MIL-F-70807 (AR)
AMENDMENT 2
19 October 1988
SUPERSEDING
AMENDMENT 1
17 October 1988

MILITARY SPECIFICATION

FUZE, PD: M745
(LESS BOOSTER AND LEAD)

FIGURE 2

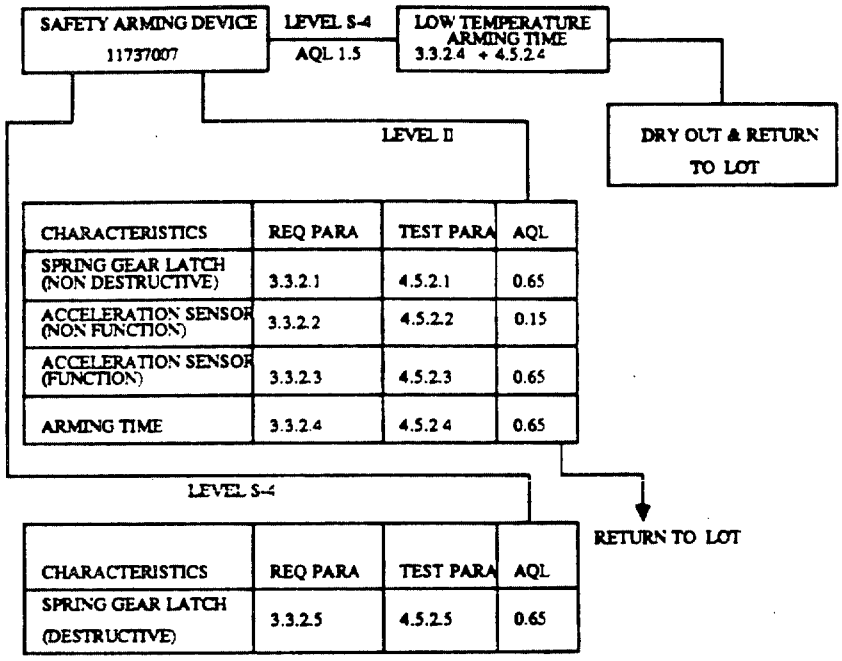
3.1.4.1 Initial production lot. Select at random ballistic lot acceptance samples from first production lot. Ballistic lot acceptance test plan is shown in figure 2.

4.4.3.1: Change "Figure 2" to read Figure 2 and 3."

4.4.3.2: Change "Figure 2" to read "Figure 2 and 3."

FIGURE 3

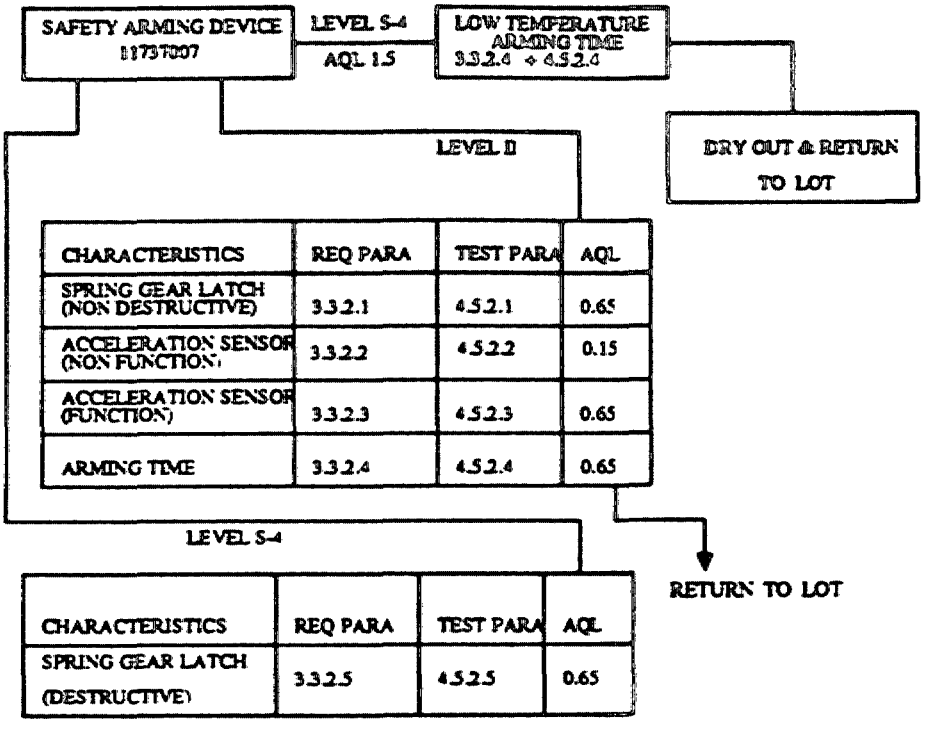
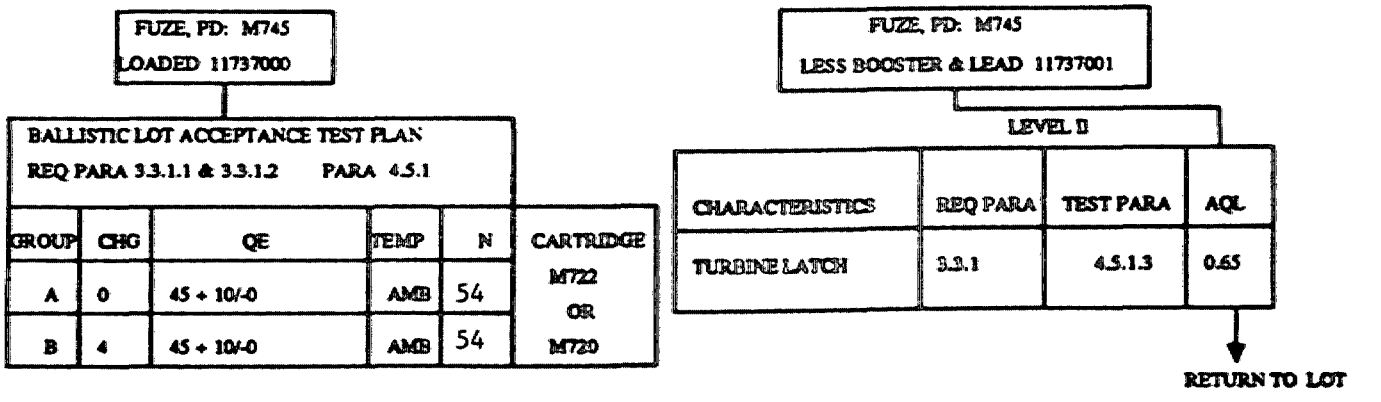
3.1.4.2 Production lot. Select at random ballistic lot acceptance samples from each production lot. Ballistic lot acceptance test plan is shown in figure 3."

FIGURE 4 INTERFACE CONTROL DRAWING

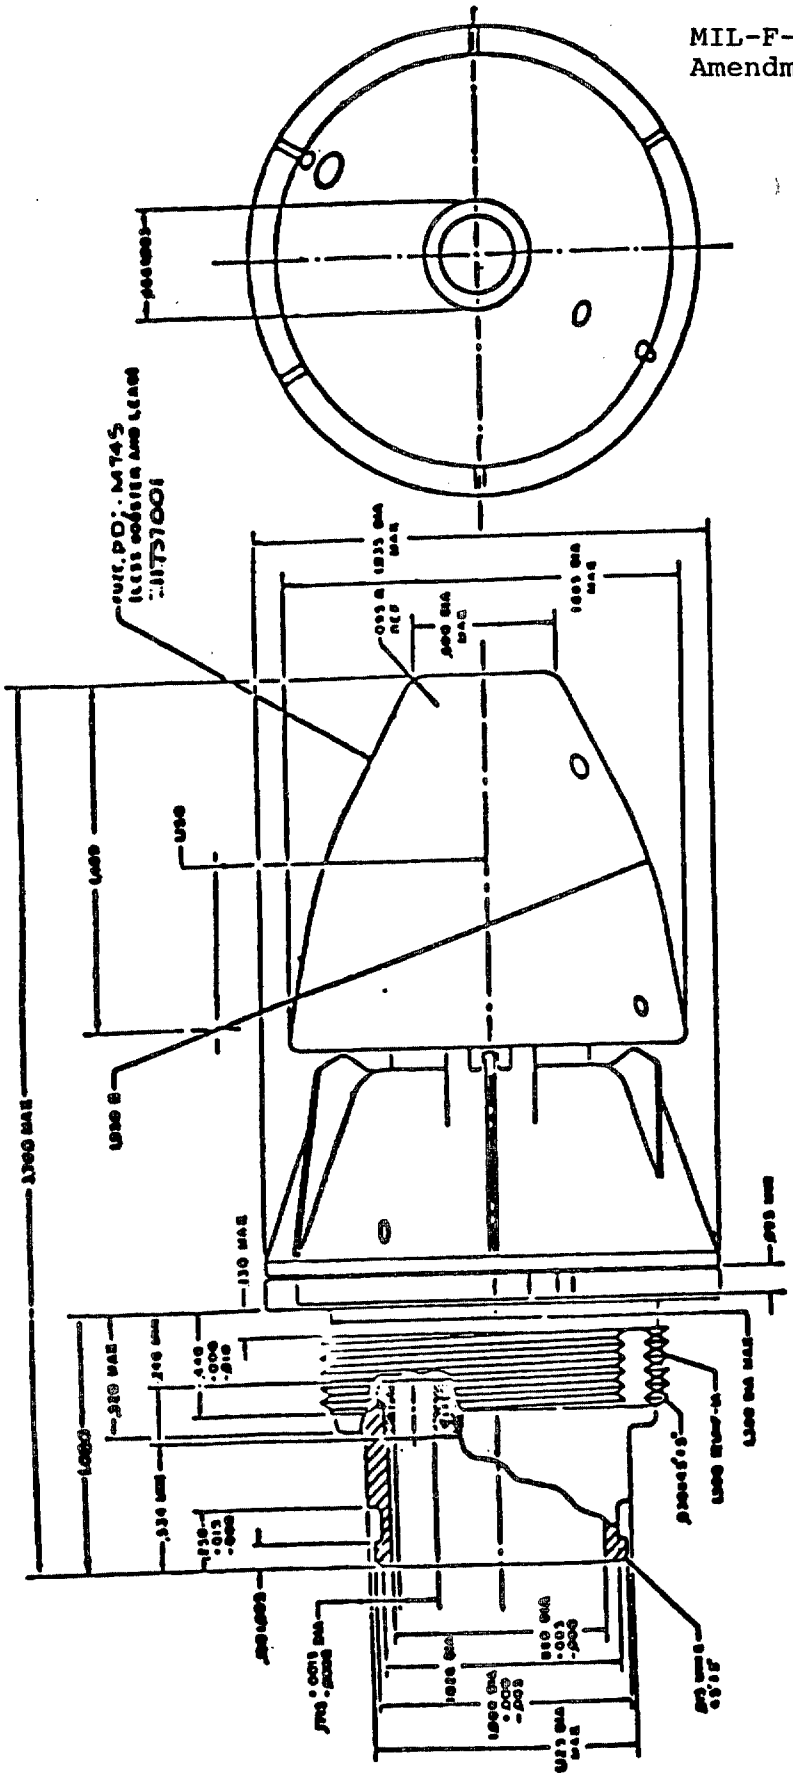
3.2: Change "(Figure 3)" to read "(Figure 4)."

Figure 4: Add new figure per included sheet.
